# **Annex Repairs & Kitchen Remodel**

Scope was updated after walkthrough on September 14<sup>th</sup> at 10AM to reflect any updates found or defined; also questions and answers attached.

# **Annex Repairs & Kitchen Remodel**

RENOVATION

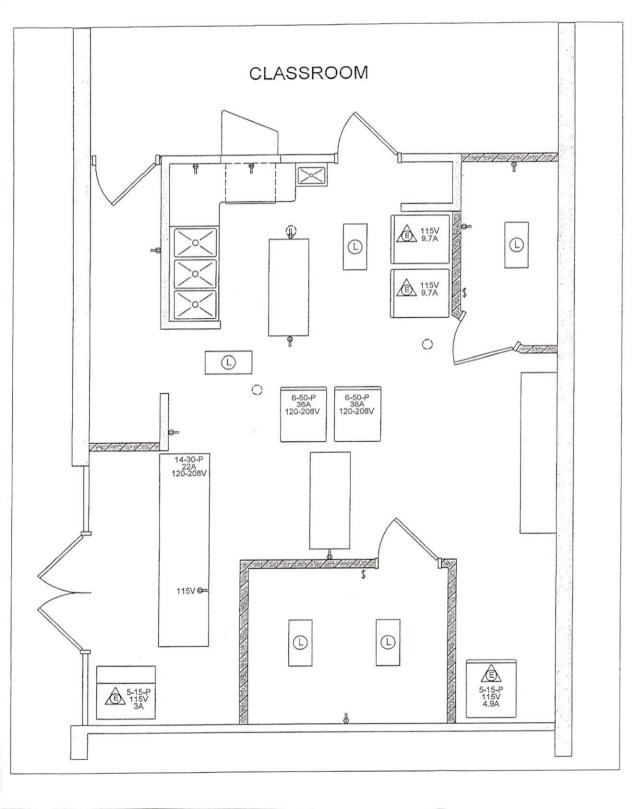
- 8. Please confirm All existing kitchen casework is to be removed and the contractor is responsible for a 3 comp sink and angled steel counter per layout shown on drawing.

- 9. During the Pre-Bid it was stated that a residential style dishwasher will be installed in the new kitchen. The layout shows the dishwasher but dishwasher is not spec'd in electrical, general, plumbing scope for rough-in. Please advise on specs and who is providing the equipment.

- Yes all casework is to be removed, Dimensions for the sink and stainless steel countertops will be updated in the drawing. All entry from the outside of the building should come through exterior walls none should be coming from underneath the building.

- Dishwasher will be provided outside of scope. Install under stainless countertop with drainage and water coming off of 3 compartment sink.
- 10. Please confirm that all patch tile work in the restrooms should be a standard white tile matching the adjacent size.
